**DESERT TORTOISE COUNCIL**

**DESERT TORTOISE PRESERVE  
COMMITTEE, INC.**

July 10, 2024

RE: Desert Breeze Solar Project Habitat Conservation Plan and Draft Environmental Assessment

**Figure 2.** Location of proposed mitigation lands to compensate for tortoise habitat lost from development of the Desert Breeze Solar Project, San Bernardino County, CA.

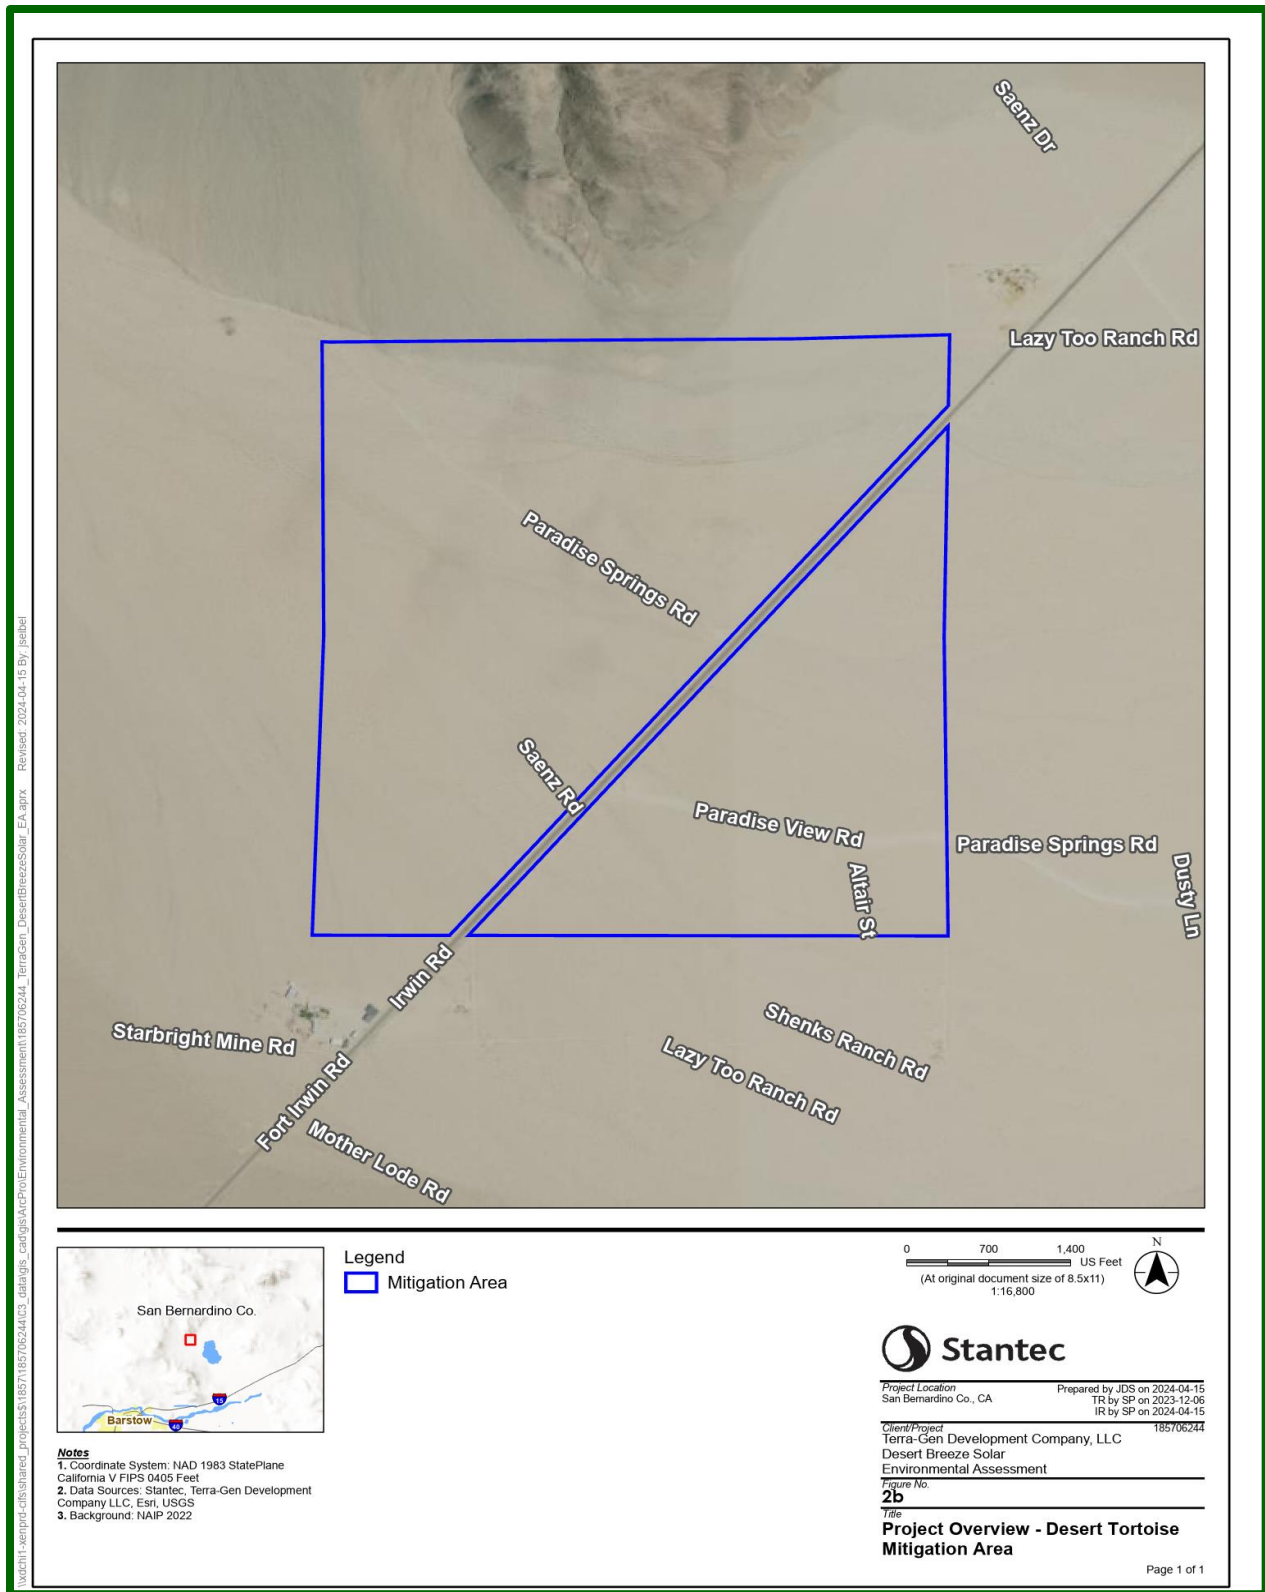
We are not sure what is meant by the general wording “funding the preservation of approximately 628.699 acres.” Please add that the mitigation land is on private land (Paradise Springs Preserve by Wildlands according to an appendix to the HCP) and appears to occupy a section of land that is bordered on the north, east, and west sides by BLM land. Depending on the management of the BLM land, which is for multiple use, the BLM land may act as a population sink for tortoises that occur in the Paradise Springs Preserve. There would be few, if any, benefits derived from the management of a small area bisected by a major road where adjacent land management results in high death rates for tortoises.

Regardless of the ownership, what permanent legally binding assurances will be placed on this proposed mitigation site to guarantee that it will be managed for the conservation and enhancement of the tortoise/tortoise habitat and contribute to the species recovery, and that safe effective connectivity between the land on the two sides of Fort Irwin Road will be constructed and maintained in perpetuity? Please add this information to this section of the HCP.

In addition, please explain why this location was selected as mitigation land when currently it has many ongoing threats to the tortoise. It is bisected by a busy highway and the numerous impacts of highway use on tortoises/tortoise habitat are well documented. They include direct mortality from vehicles and transport/spread of non-native invasive plants, increased occurrence of fires, changes to tortoise behavior near a roadway, and food subsidies for tortoise predators.

Until these and other questions are answered in the HCP and Draft EA, this parcel does not appear to mitigate the impacts of the taking to the maximum extent practicable. It appears to possess numerous impacts to tortoise/tortoise habitat because of its location and occurrence of a major road through the middle of the mitigation site and proximity to human development that subsidizes predators of the tortoise. Consequently, for the reasons stated above, we disagree with the statement in the HCP that “[t]his proposed mitigation strategy would offset the loss of suitable habitat and potential take of desert tortoise associated with the proposed action.” In addition, the mitigation is not required for the potential take of the tortoise. The mitigation is required for the “impacts of the taking.” Please correct this statement in the HCP and revise the discussion to explain how the proposed mitigation would offset the impacts of the taking of the tortoise.
